**BID PACKAGE A - SITE PREPARATION  
THE GIVING TREE CHILDCARE CENTER, INC.  
CLARKSVILLE, TN**

**ADDENDUM NO. THREE**

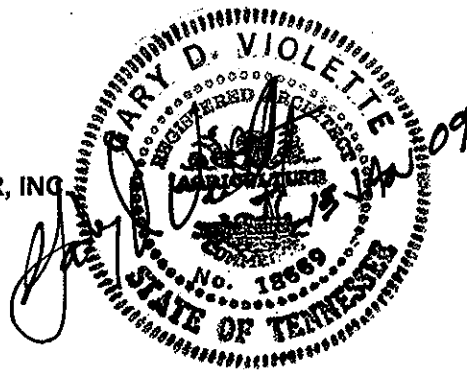
SHEET C101, DRAINAGE AND EROSION CONTROL; Add the DETENTION BASIN CROSS SECTION attached hereto. CLARIFICATION: Cut earth berm to form weir as shown.
